SCHROEDER ELEMENTARY SCHOOL

ADDENDUM NO. 1
TO THE
PLANS AND SPECIFICATIONS
FOR
SCHROEDER ELEMENTARY SCHOOL
DSA 04-101569

ADDENDUM NO. 2
TO THE
PLANS AND SPECIFICATIONS
FOR
SCHROEDER ELEMENTARY SCHOOL
DSA 04-101569

ADDENDUM NO. 3
TO THE
PLANS AND SPECIFICATIONS
FOR
SCHROEDER ELEMENTARY SCHOOL
DSA 04-101569

SHEET OF
AD2-5
(E-2.1.2)

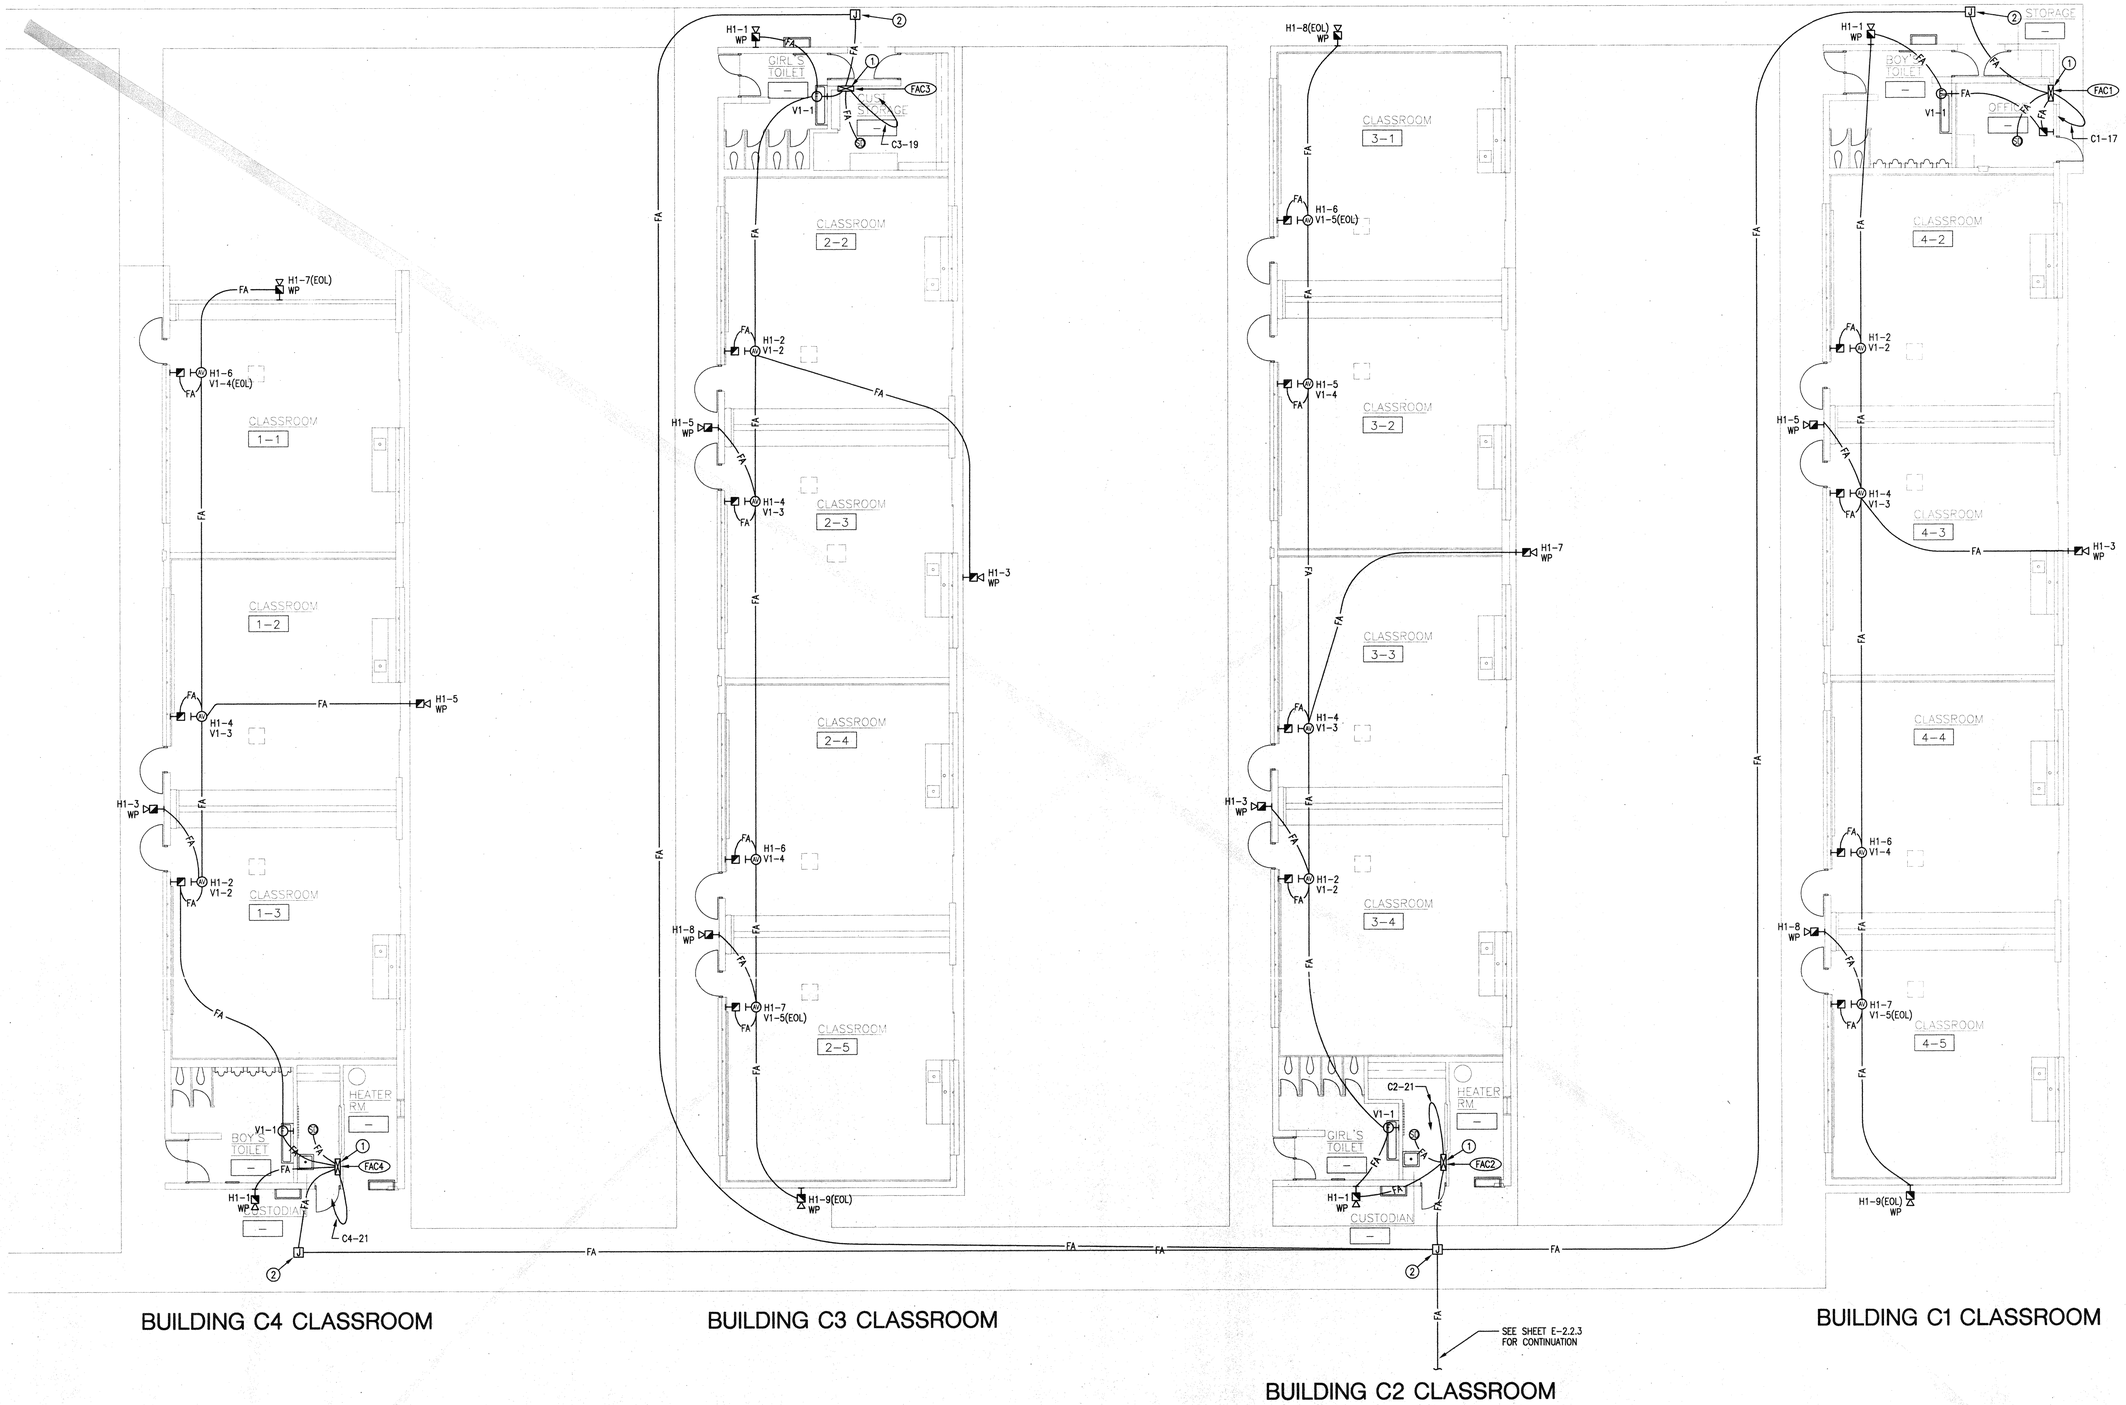
8. **ADDENDUM DRAWING AD2-5** is issued with this Addendum #2 to show ADDED power wiremold 4000 in all classrooms.

SHEET OF
AD1-11
(E-2.1.3)

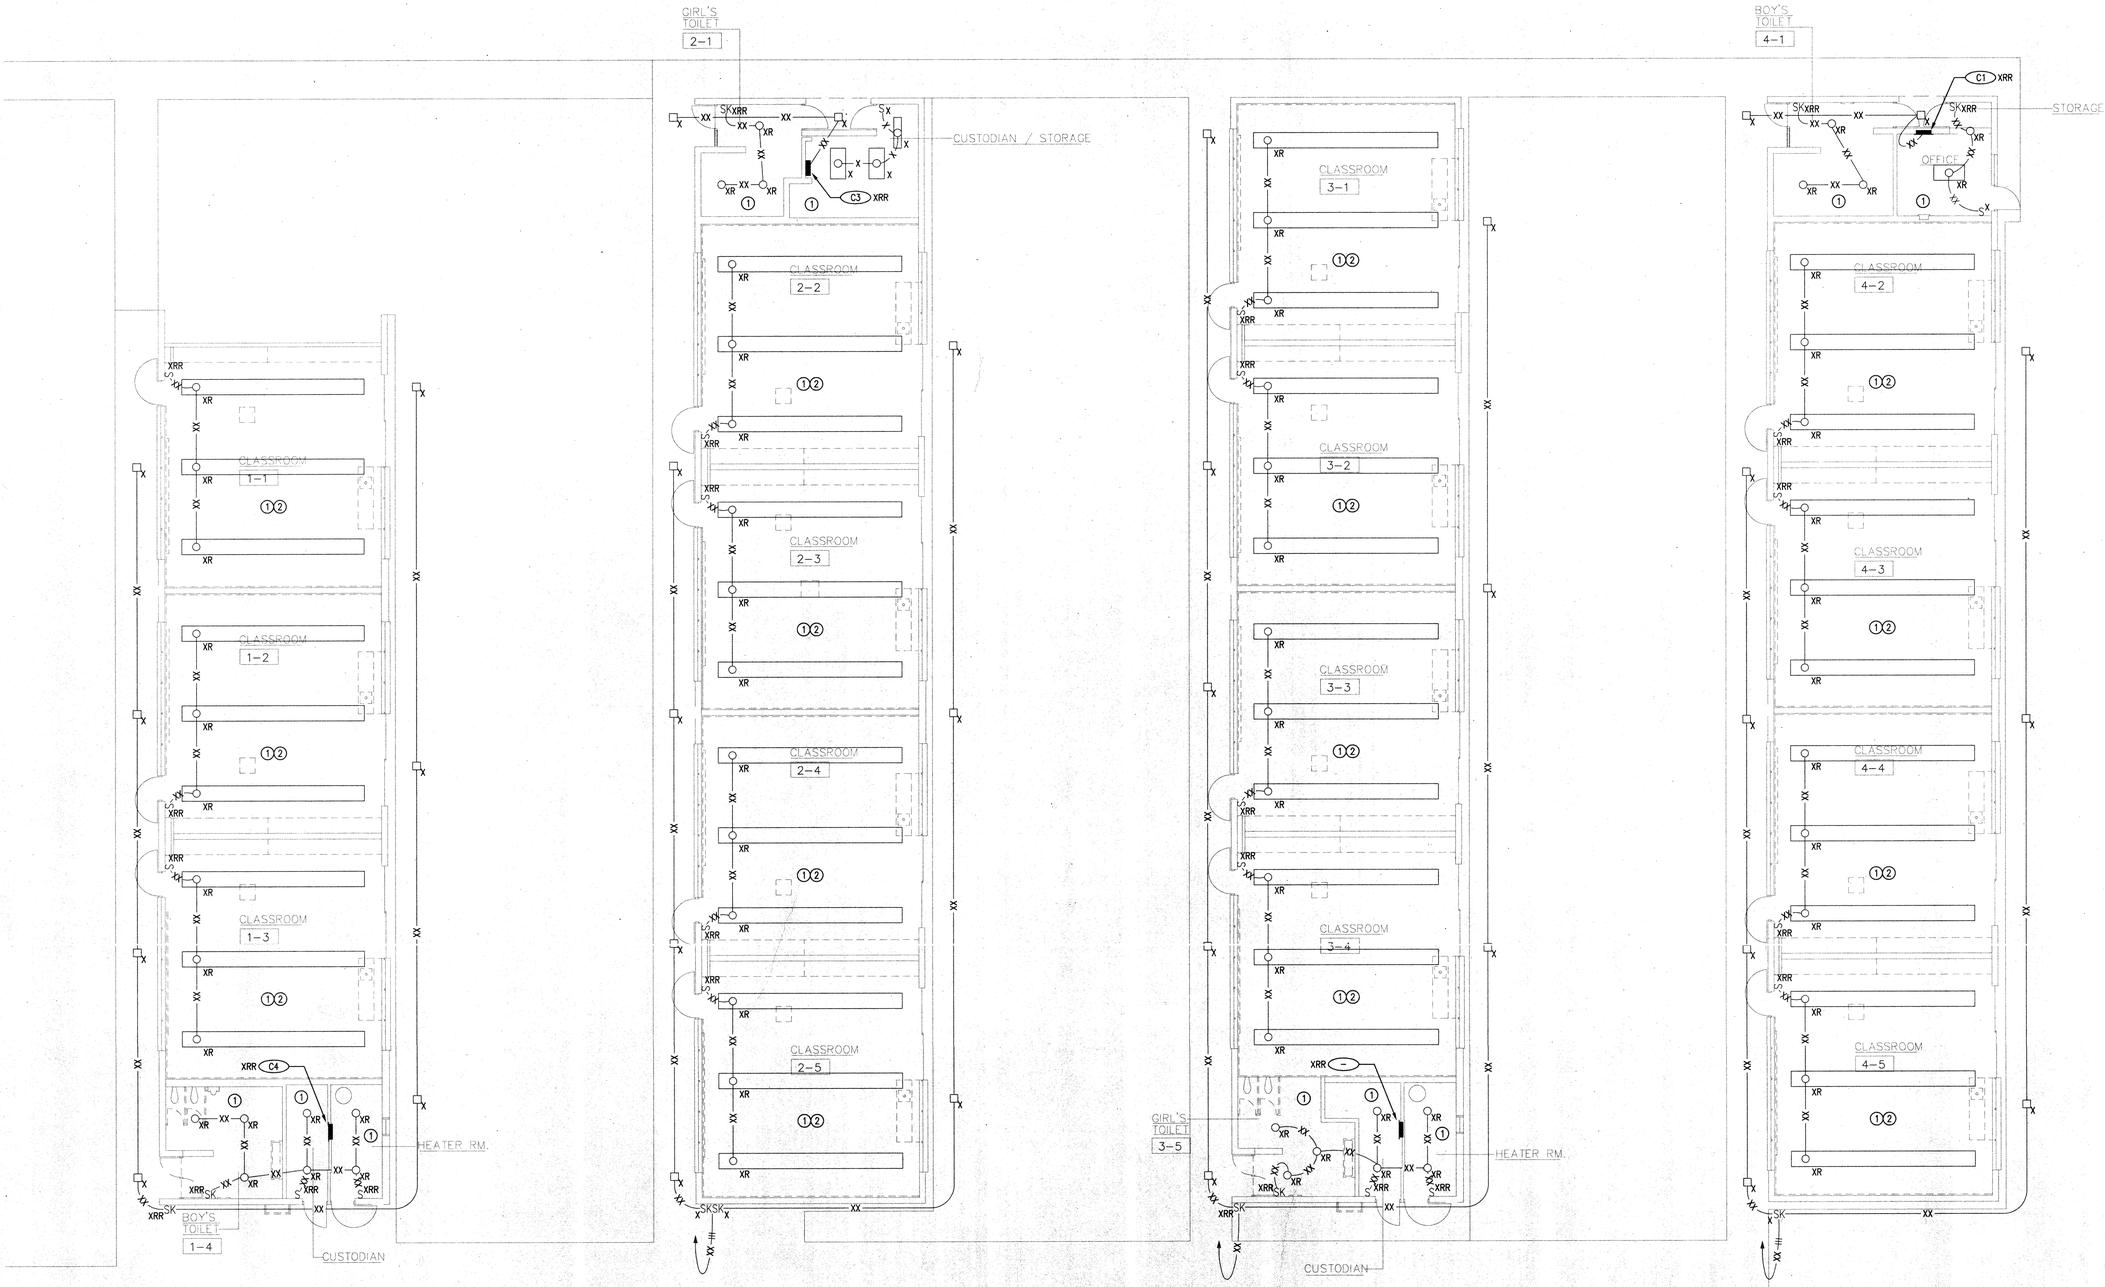
18. **ADDENDUM DRAWING AD1-11** is issued with this Addendum #1 to show:
   a. Relocated fire alarm horn / strobe (AV) throughout.
   b. Added fire alarm strobe (F) at Reading Room - Bldg. #2 and Office Room - Bldg. #4.
   c. Revised buildings name designation.
